### RE: Subgrade Inspection for Lot # 15 Woodside Ridge – 2029 NW Ashurst Dr Lee's Summit, MO 64081 – Permit # PRRES20204535

On January 20, 2021, a special inspection was performed by Residential Engineering Services, LLC (R.E.S.) at the above referenced property. The purpose of this inspection was to determine structural adequacy of the existing soil for construction of concrete foundation.

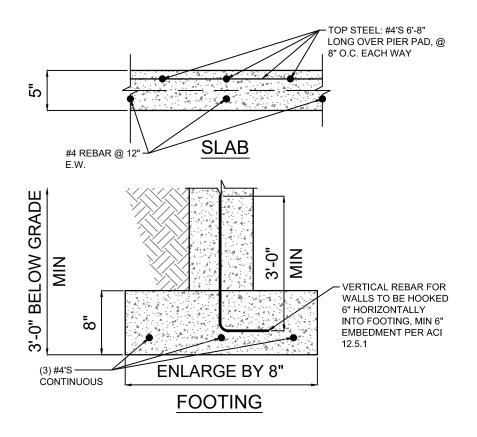
- The soils observed at footing elevation were silty clay; light-medium brown; median plasticity and dry with several loose rocks.
- Probes and penetrometer readings indicated that the soils do not have sufficient bearing capacity for the loads applied by foundation per permit plans.

- RES recommends that the footings be enlarged to 24"X8" with three (3) #4 rebar continuous (see attached specifications).
- Basement and garage pier pads shall be enlarged a minimum of 6" each way (i.e existing 30"x30" shall be enlarged to 36"x36", etc.) (see attached specifications).

- MAXIMUM 9'-0" WALL HEIGHT
- USE REBAR AS SHOWN ON DRAWING OR XX LB/YD<sup>3</sup> HELIX 5-25 DESIGNED IN ACCORDANCE WITH UNIFORM-ES ER-0279

- SLAB HELIX DOSAGE = 12.5 LB/YD<sup>3</sup>
- FOOTING HELIX DOSAGE = 12.5 LB/YD<sup>3</sup>
- PIER PAD HELIX DOSAGE = 12.5 LB/YD<sup>3</sup>
- HORIZONTAL REBAR IS NOT REQUIRED IN FOOTINGS FOR HELIX
- SLAB ONLY REQUIRES TOP STEEL REBAR OVER PIER PADS FOR HELIX
- VERTICAL REBAR IN WALL IS STILL REQUIRED. HOOK REBAR 6" HORIZONTALLY INTO FOOTING @ 24" O.C.
